re: Geotechnical Recommendations - Grading Plan Review and Frost Protection
Proposed Warehouse Buildings
Campeau Drive at Huntmar Road
Ottawa, Ontario

date: May 30, 2023

file: PG6394-MEMO.02

1.0 Grading Plans Review

TREE PLANTING SETBACK RECOMMENDATIONS

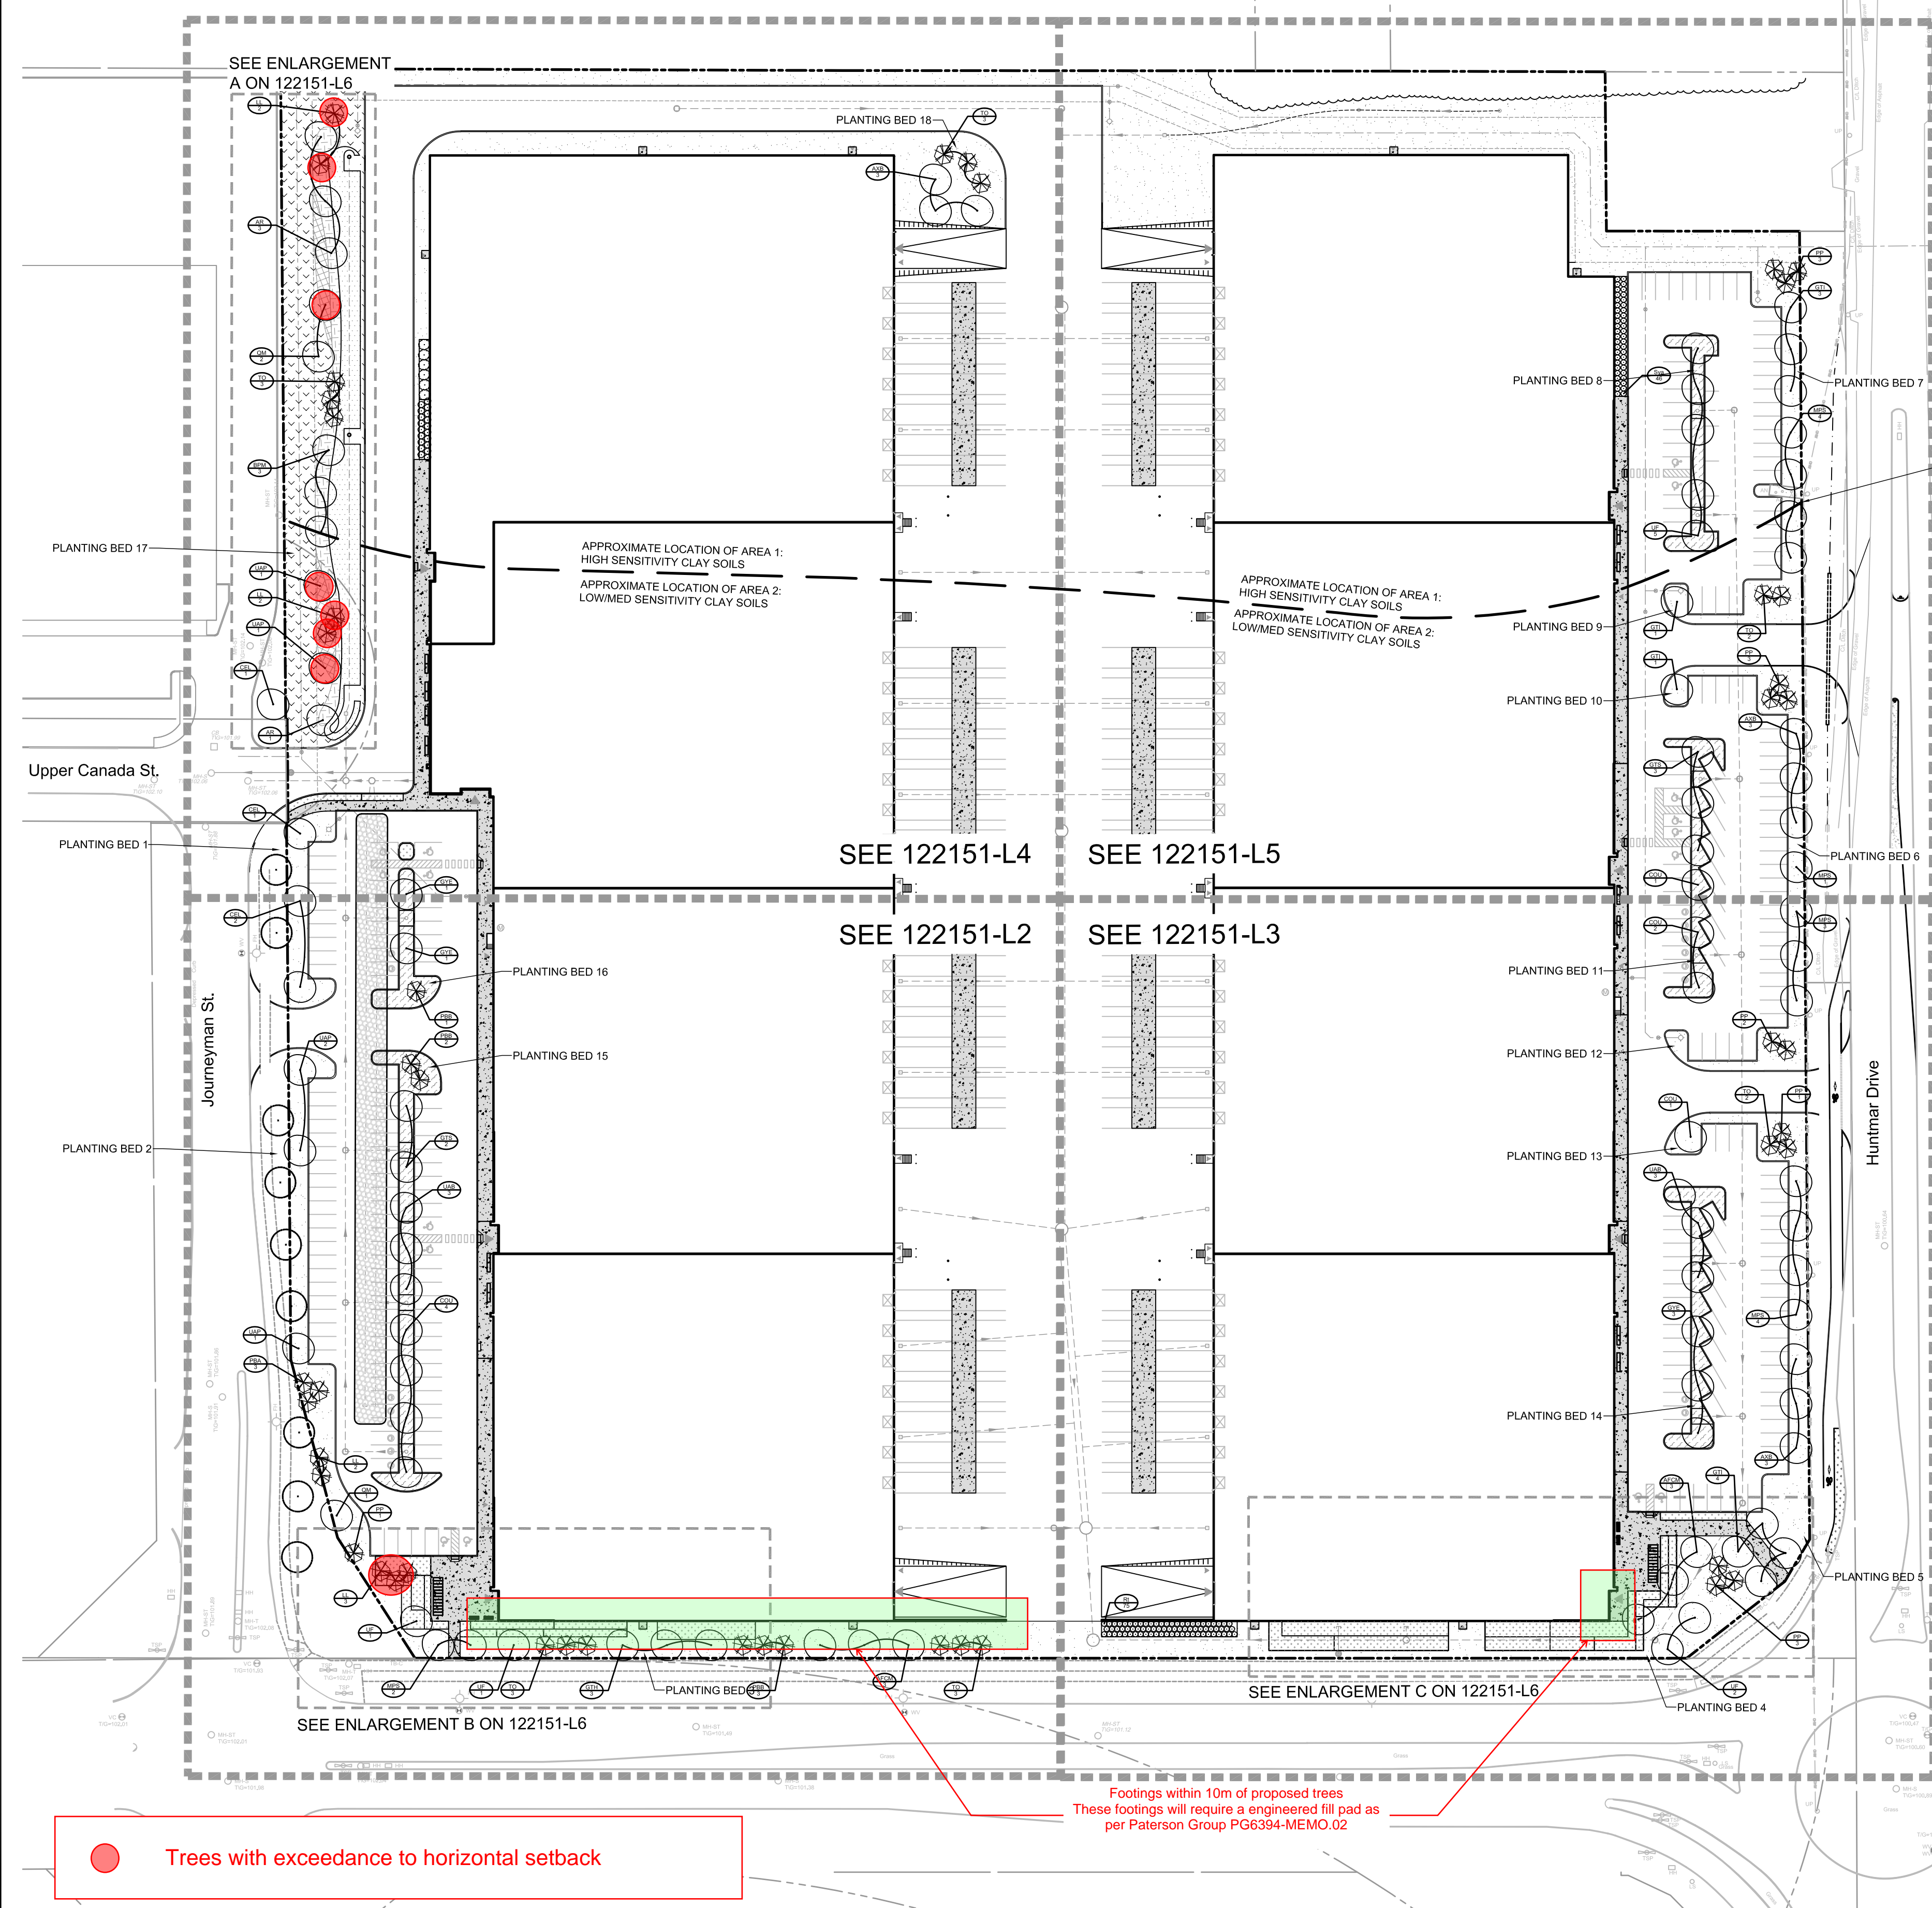
As noted in the above-mentioned geotechnical report, Atterberg limits testing was completed on selected samples at the subject site. Two tree planting setback areas are present within the proposed development and are outlined in the attached Drawing PG6394-2 - Tree Planting Setback Recommendations. The following general recommendation are required for Area 1 and Area 2:

- AREA 1 - 7.5m TREE PLANTING SETBACKS
- AREA 2 - 4.5m TREE PLANTING SETBACKS

PG6394-MEMO.02 - Grading Plan and Landscaping Plan

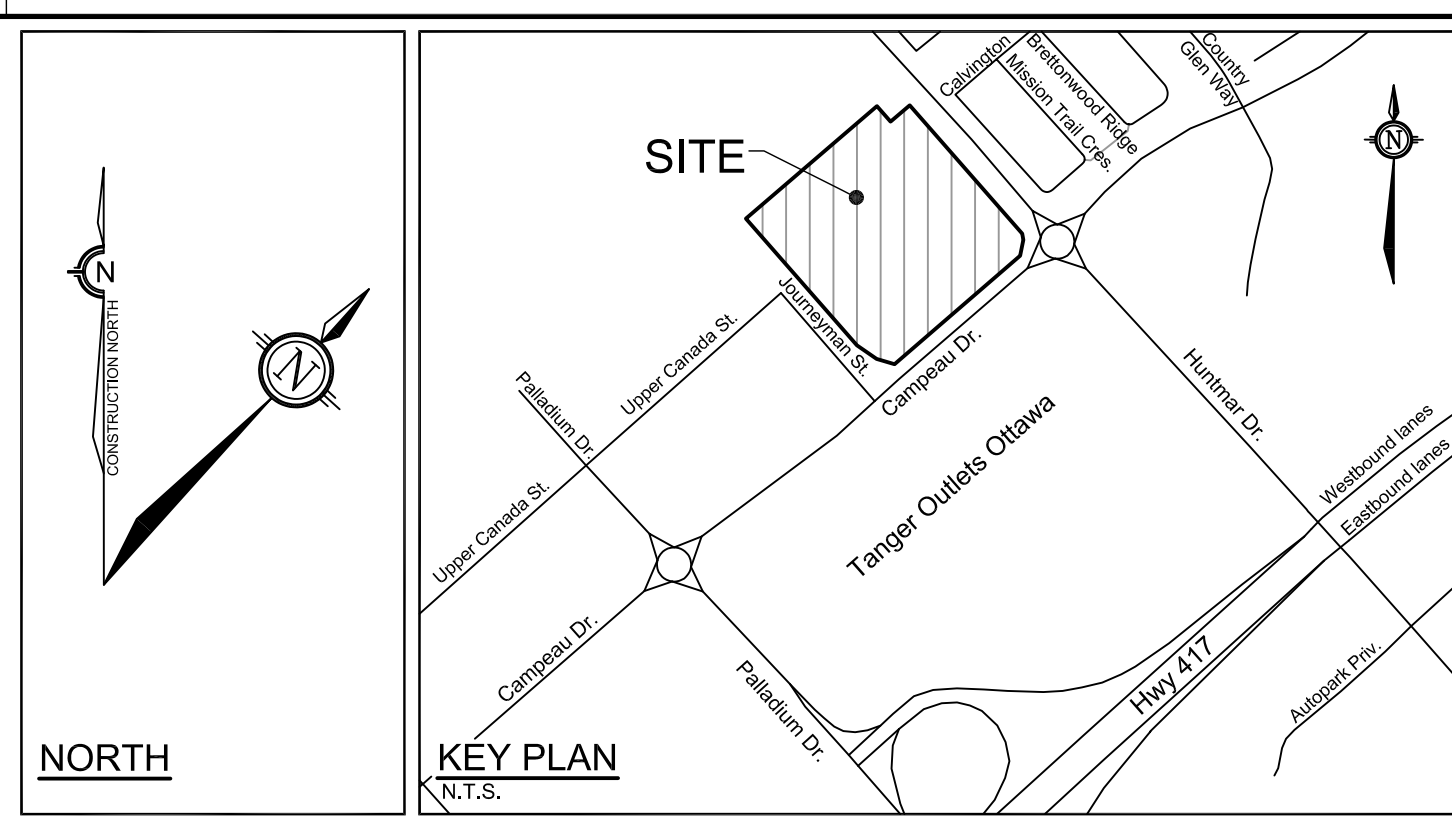
Based on our review of the above noted drawings, all footings were observed to have sufficient horizontal setback from proposed trees with the exception of some LL, UAP, and QM trees within buildings B1, B3, and B4, noted in the above table. These trees should either be sufficiently spaced from the building footprint at a minimum distance equal to the mature tree heights (20 to 30m) or should be replaced with small to medium trees with a maximum mature height of 14m.

Based on our review, it was further noted that the footings along the southern foundation wall of building B1 and the footings at the southeast corner of Building A1 will be located within 10m from the proposed trees, and therefore, will require to have a minimum embedment depth of 2.1m below finish floor elevation as per City guidelines for planting in sensitive marine clays. To compensate for the reduced foundation depth for the impacted footings, an engineered fill pad can be placed below the underside of footing to an elevation matching a depth of 2.1 m below proposed finished grade surrounding the buildings. The engineered fill pad will effectively increase the depth between the finished grade and the underlying silty clay deposit to the required 2.1 m which achieves the same goal as lowering the footing from a tree planting perspective. The granular pad should consist of OPSS Granular A or Granular B Type II placed in 300 mm loose lifts and compacted to 98% of the material's SPMDD. The granular pad should be extended horizontally a minimum of 150 mm beyond the footing edges in all directions and a minimum 1.5H:1V down and out from the footing face. Reference can be made to Figure 1 - Engineered Pad Below USF For Tree Planting Purposes attached for additional information.

Reference should be made to the attached markup drawing for the location of the effected footings.

● Trees with exceedance to horizontal setback

Figure 1 – Engineered Pad Below USF For Tree Planting Purposes

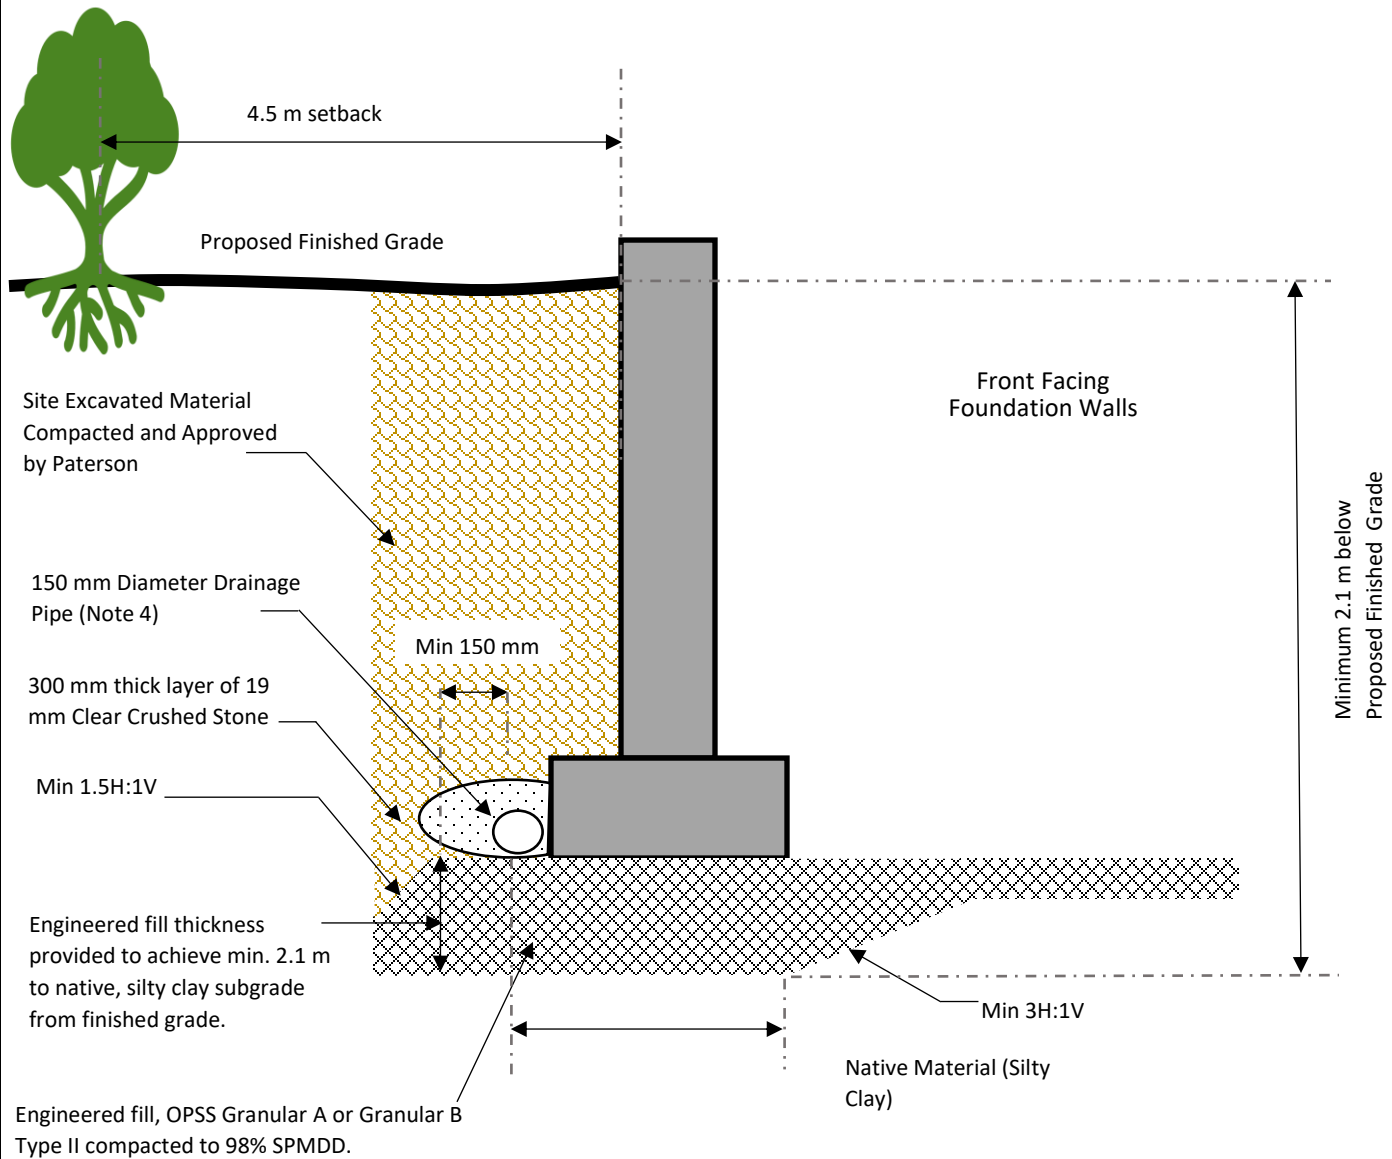
- Note 1: Where footings have a minimum depth less than 2.1 m below finished grade, a granular pad below the footings will be required.
- Note 2: The thickness of the engineered pad is dependent of the depth of footings below proposed grade. The thickness of the engineered pad can be calculated by subtracting the depth of footing from 2.1 m.
- Note 3: The placement of the engineered fill should be reviewed and approved in the field by Paterson
- Note 4: The 150 mm diameter perforated, corrugated drainage pipe should be geotextile wrapped, placed at the founding level and connected to a positive outlet with a gravity connection.
